**SOLICITATION AMENDMENT
MODIFICATION DE L'INVITATION**

Title - Sujet 50 Bed Living Unit, Westmorland Ins	
Solicitation No. - N° de l'invitation EC016-130878/A	Amendment No. - N° modif. 003
Client Reference No. - N° de référence du client R.043929.001	Date 2012-08-21
GETS Reference No. - N° de référence de SEAG PW-\$PWB-020-3101	
File No. - N° de dossier PWB-2-35024 (020)	CCC No./N° CCC - FMS No./N° VME
Solicitation Closes - L'invitation prend fin at - à 02:00 PM on - le 2012-09-13	Time Zone Fuseau horaire Atlantic Daylight Saving Time ADT
F.O.B. - F.A.B. Plant-Usine: <input type="checkbox"/> Destination: <input type="checkbox"/> Other-Autre: <input type="checkbox"/>	
Address Enquiries to: - Adresser toutes questions à: Donovan, Janine PWB	Buyer Id - Id de l'acheteur pwb020
Telephone No. - N° de téléphone (506) 636-5347 ()	FAX No. - N° de FAX (506) 636-4376
Destination - of Goods, Services, and Construction: Destination - des biens, services et construction:

This Tender Amendment Number 3 is raised to include the following **Addendum No. 3.**

Addendum No. 3

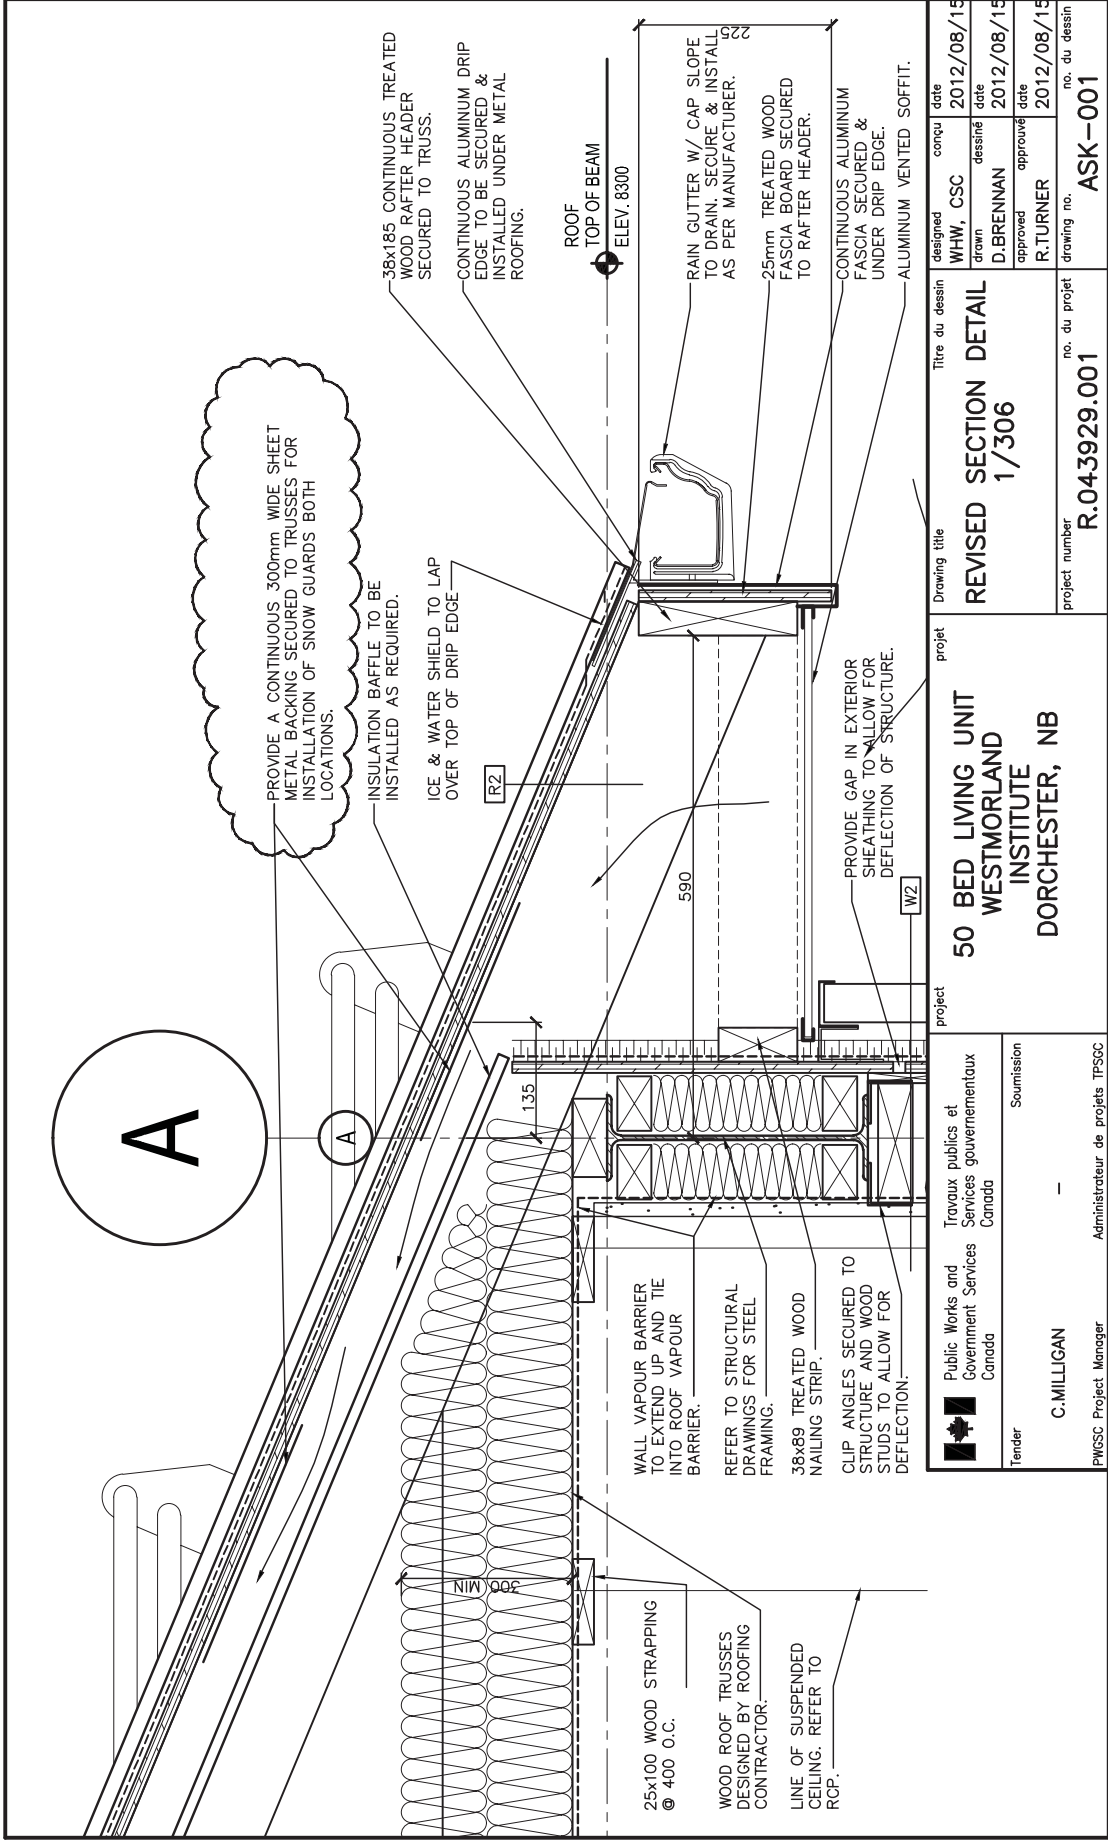
.9 Reference Drawing A-306:

- .1 Detail 1/306 revised to show sheet metal backing for Snow Rail support in accordance with attached sketch ASK-01.
